## FIELD INSPECTION

<b>Project Name:</b>	Mountain Valley Pipeline	<b>Inspector:</b>	Matthew Grant
<b>Inspection Date:</b>	Thursday, September 26, 2019	<b>Project Contact:</b>	Brian Clauto
<b>Spread: Montgomery Co. AR MN 278.01 MP237.3-235.7</b>	Spread H	<b>Weather (Wet/Dry/Rain):</b>	Dry

## FIELD INSPECTION PHOTO LOG

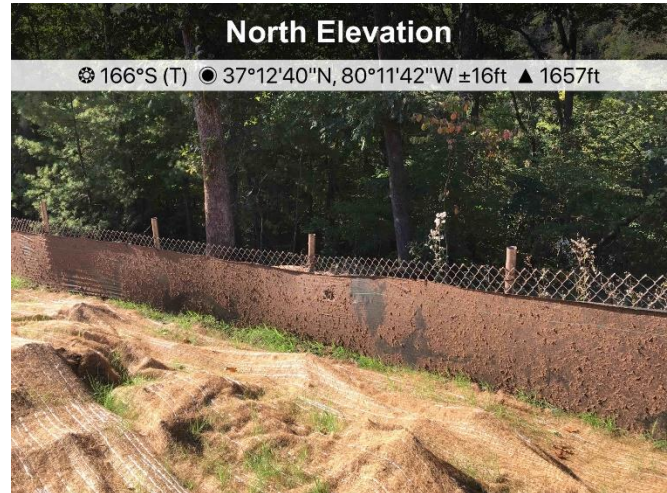
- Fig. 2. St12539+15 SSF has a hole in it and requires maintenance.

- Fig. 3 St12533+62 CFS has a hole in it and requires maintenance.

**Recommend Corrective Action:** Maintain and install all controls per the approved plan and specs

**Deadline:** Within 24hr notification
